AZUCENA STREET
30-INCH SEWER PROJECT

SAWS Job. No. 11-4518
SAWS Solicitation No. B-12-059-DD

ADDENDUM NO. 3

October 8, 2012

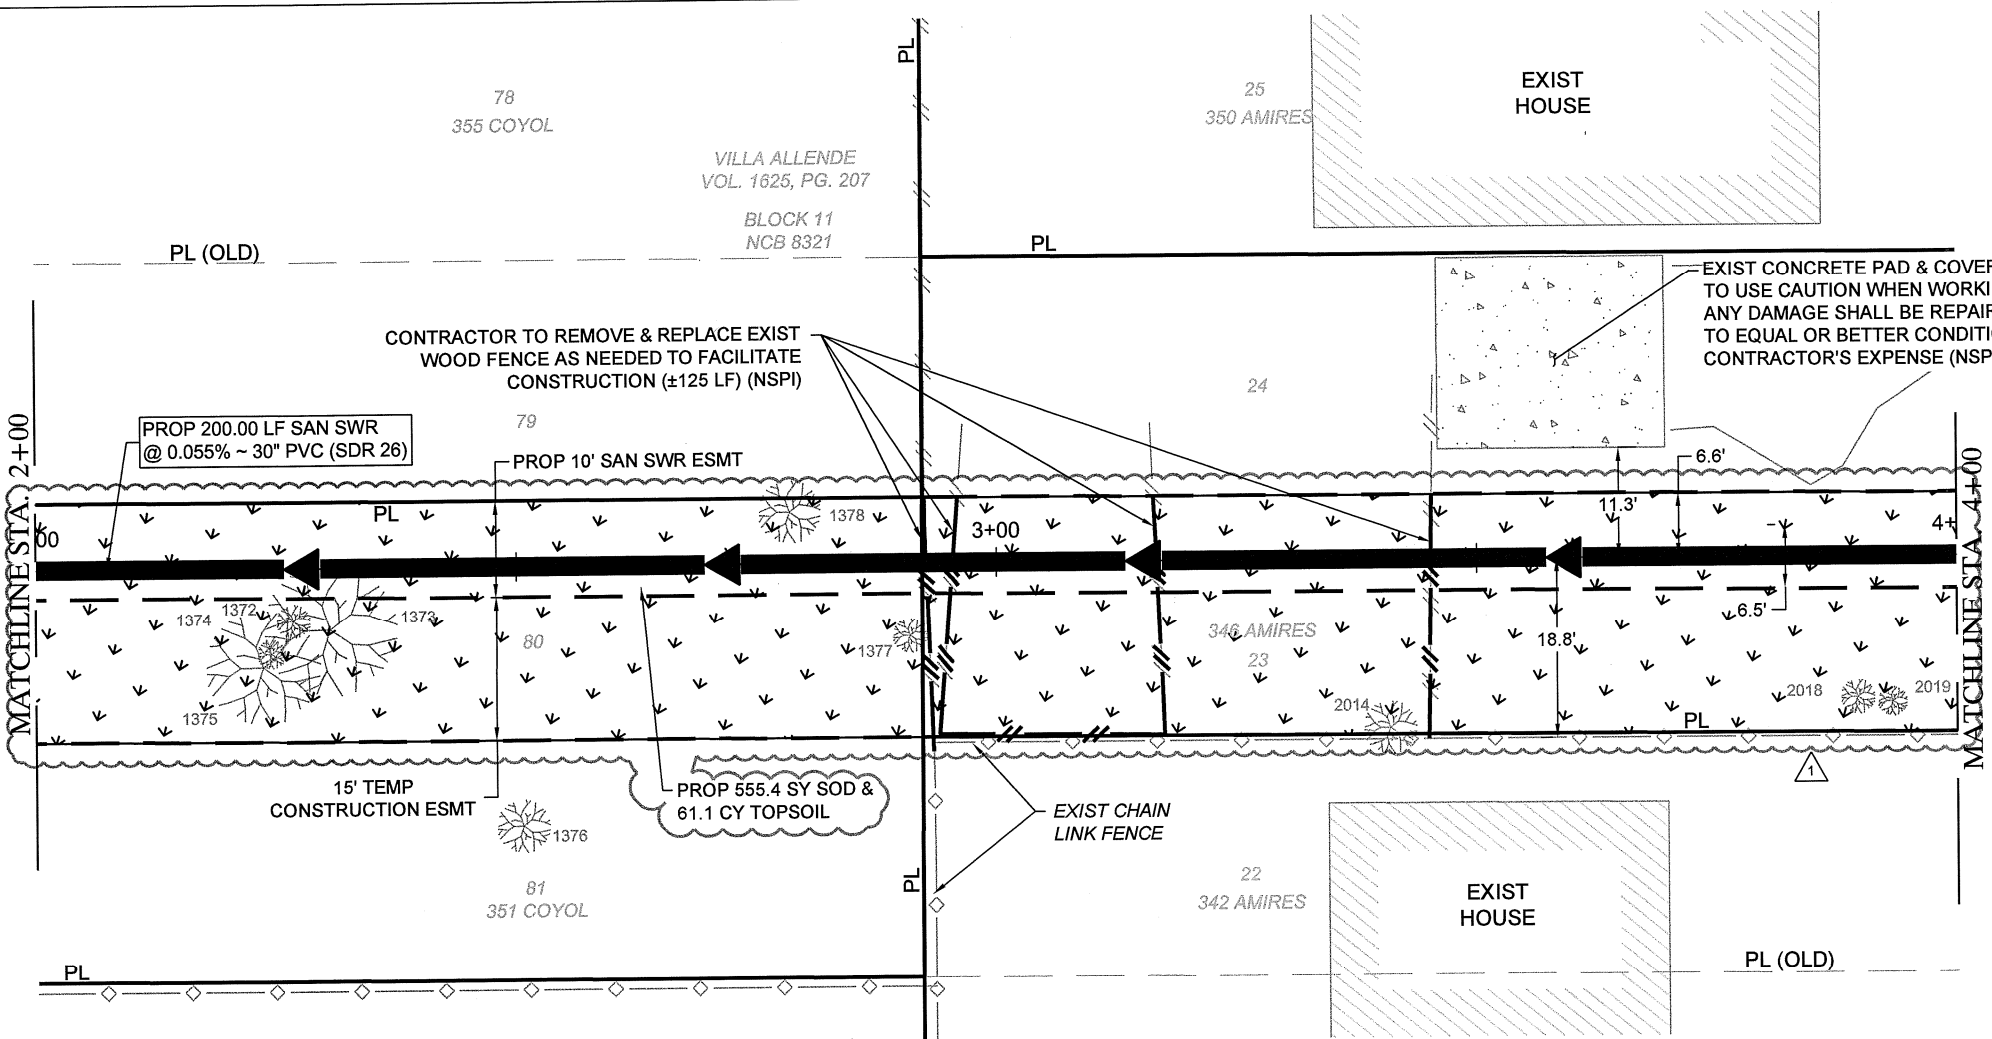
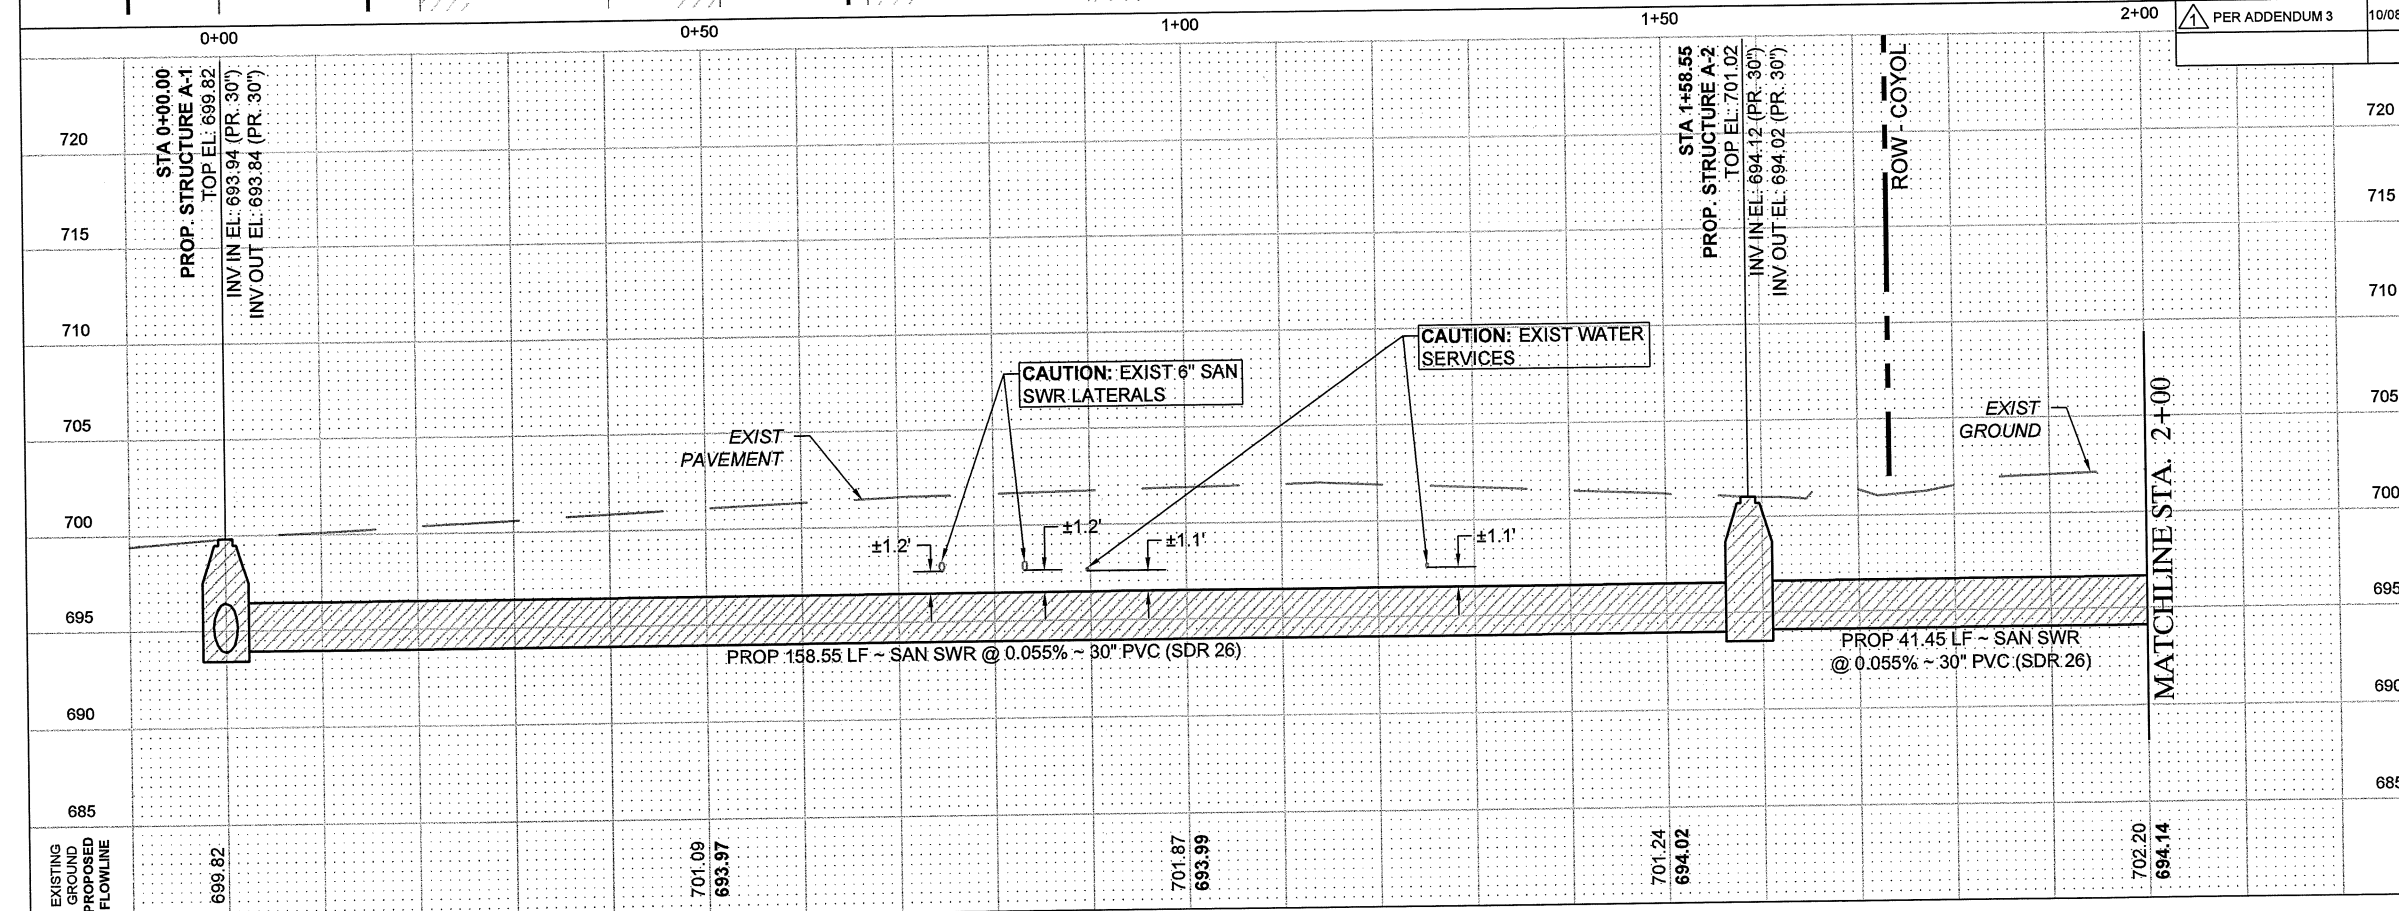
F. **Construction Plans – Sheet 10** – Remove in its entirety and replace with the revised “Sheet 10 – Line A – 30-Inch Sewer Plan & Profile – Sta. 0+00 to Sta. 2+00” attached.

- Q7: For consistency amongst all bidders will the owner/engineer please provide the most recent CoSA sidewalk & driveway design/construction guidelines for excavation in streets as referenced in Note 6 found on Sheet 10, and other various plan sheets?

- A7: These guidelines may be obtained from the City of San Antonio’s website provided at the end of the contract documents.**
- Q8: Will the owner/engineer consider adding a bid allowance for misc. repairs (sidewalk, driveway, seed/sod, etc...) associated to the installation/repair of sanitary sewer laterals?

SHEET 11 OF 34

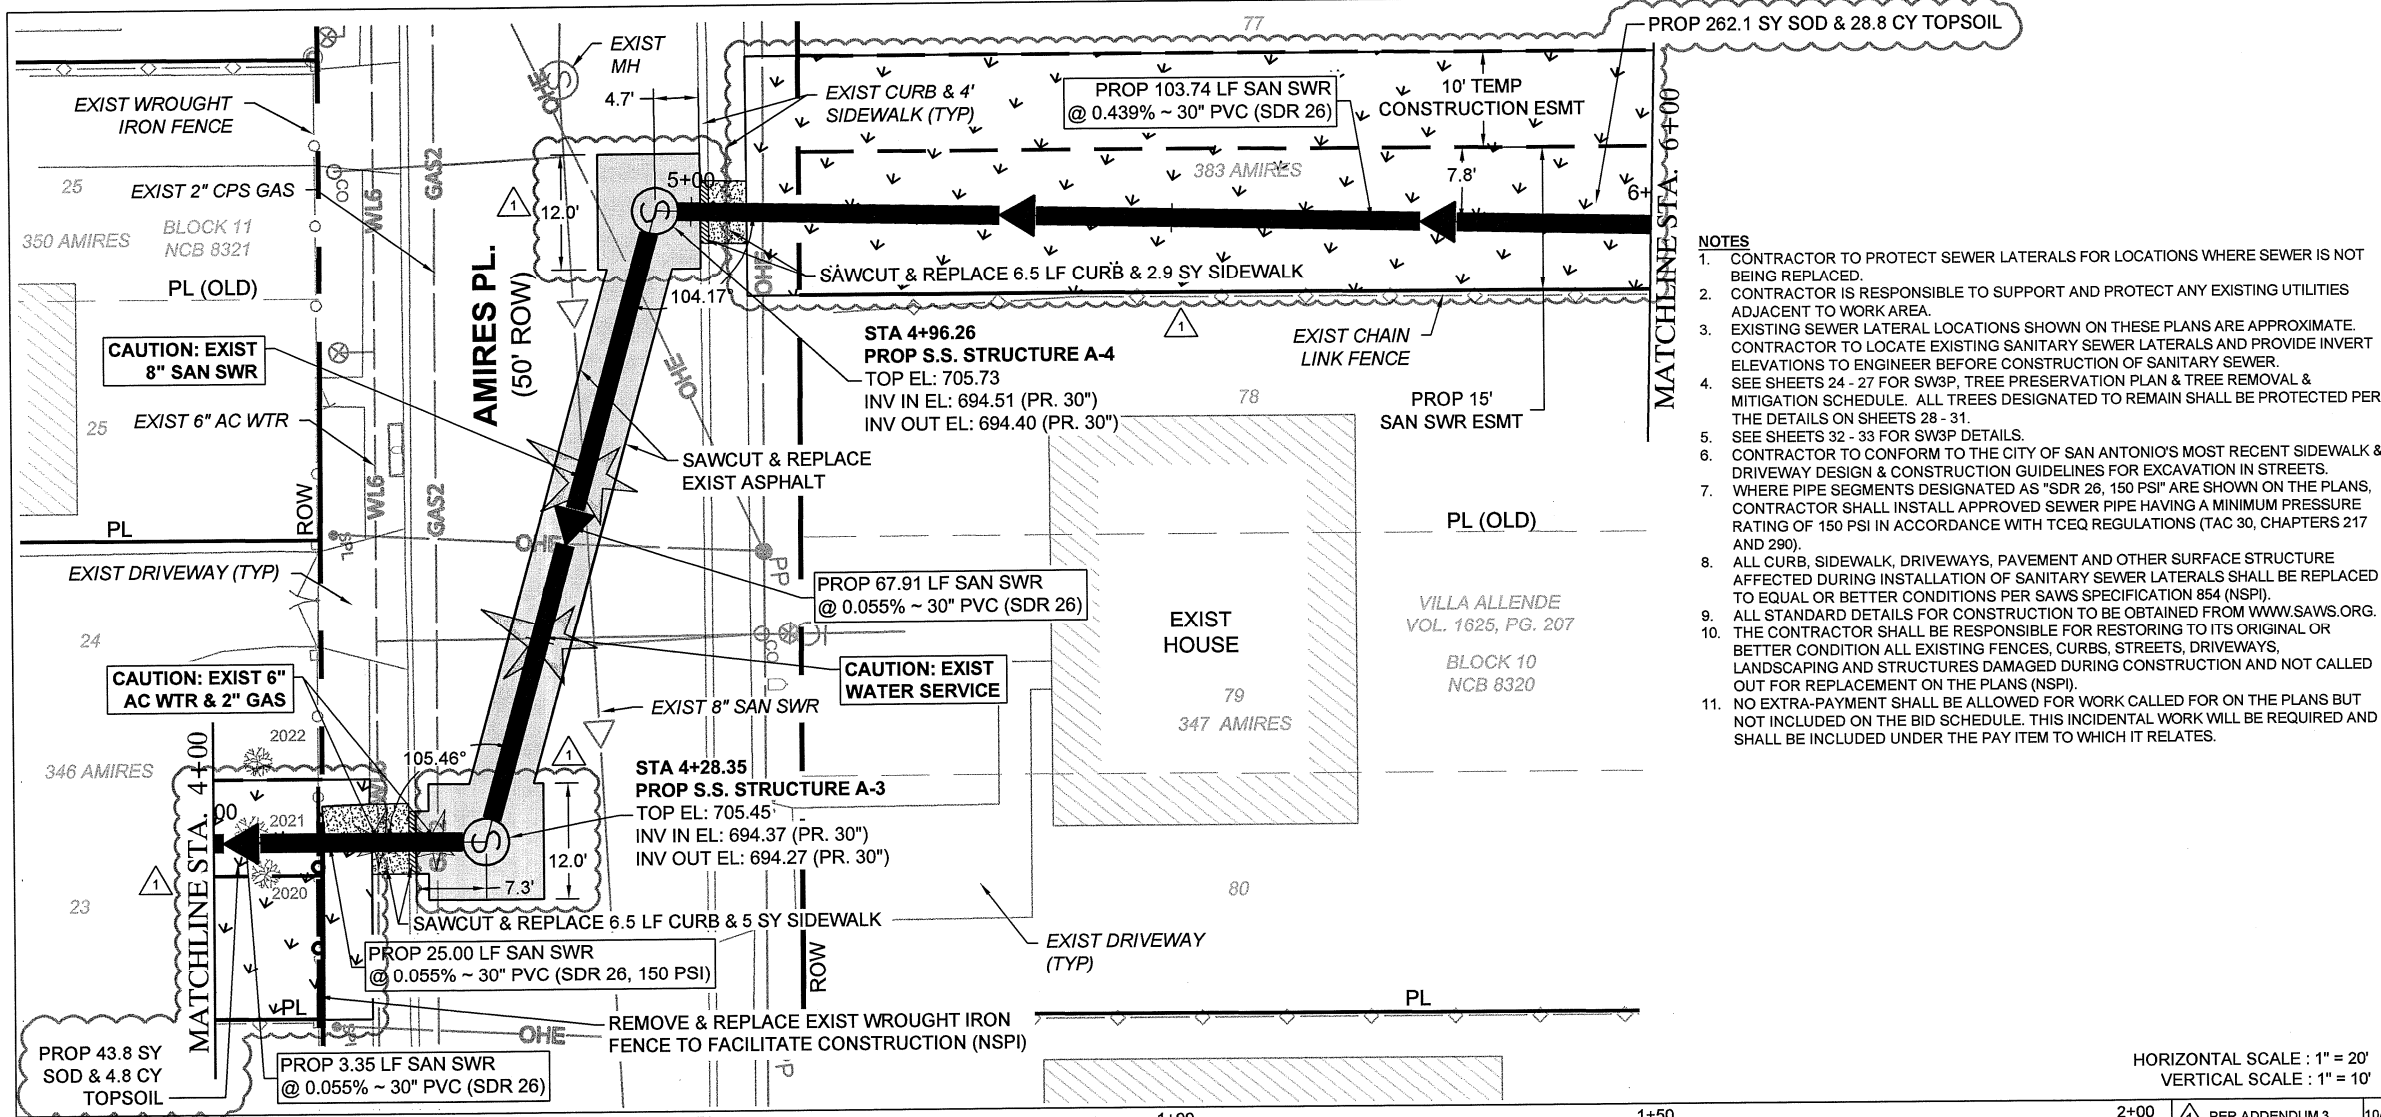
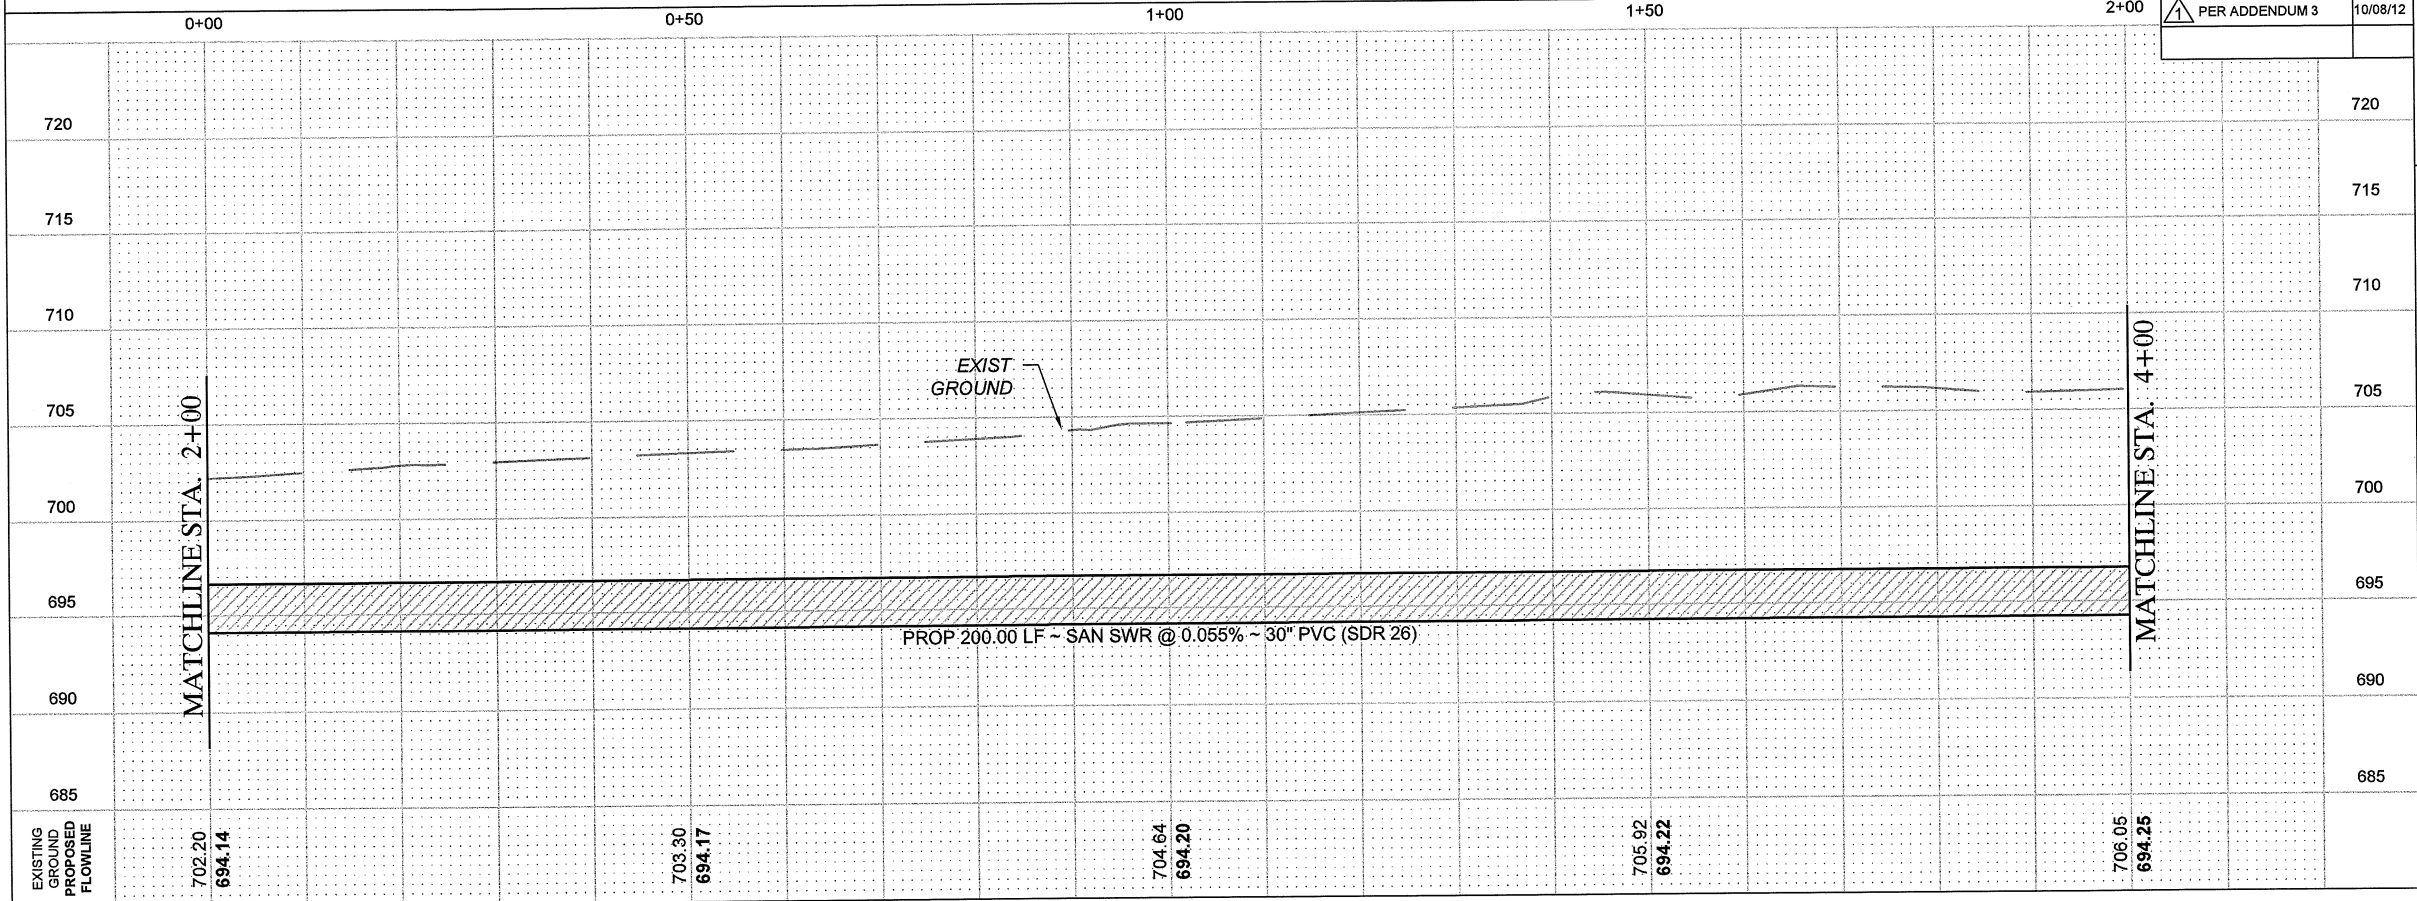
G. **Construction Plans – Sheet 11** – Remove in its entirety and replace with the revised “Sheet 11 – Line A – 30-Inch Sewer Plan & Profile – Sta. 2+00 to Sta. 4+00” attached.
